Parish Council Response to Planning Application 20260207

Land North of Camer Road, Meopham

Formal Objection Statement

Figure 1 - Proposed roundabout access on Camer Road (approximately 45m diameter). Source: Access Road Layouts; ES Vol II Appendix 3.1 Detailed Access Drawings.

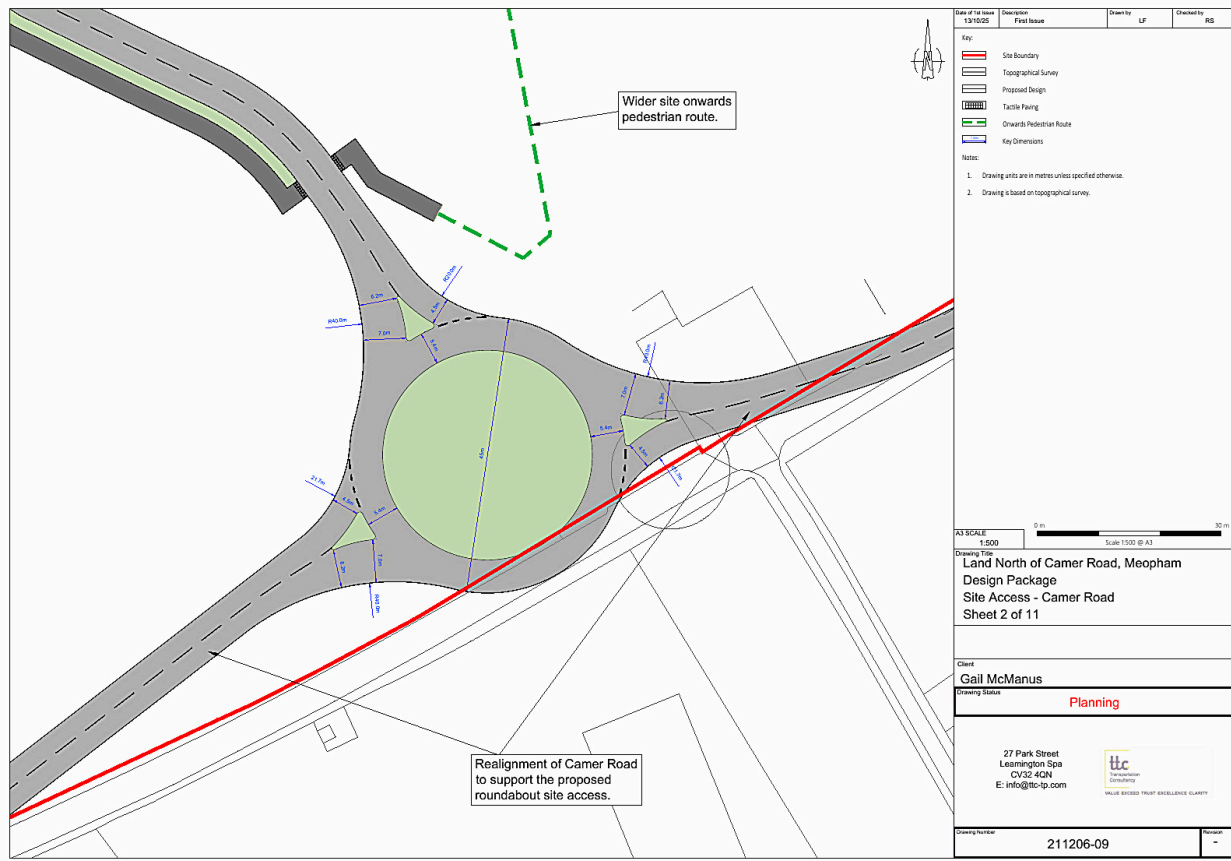
The drawings indicate that the proposed roundabout would be approximately 45 metres in diameter, representing a substantial new highway feature within the existing road corridor (Access Road Layouts; ES Vol II Appendix 3.1 Detailed Access Drawings).

The transport impacts of the development are assessed by the applicant as minor adverse and not significant following mitigation. However, the same material shows that the proposal would require substantial alterations to the existing highway environment, including a large new roundabout junction and associated road widening works.

The Parish Council therefore objects to the application on the basis that the scale of the proposed highway infrastructure and the forecast traffic increases identified within the

transport material raise substantive planning concerns which have not been satisfactorily resolved within the submitted material.
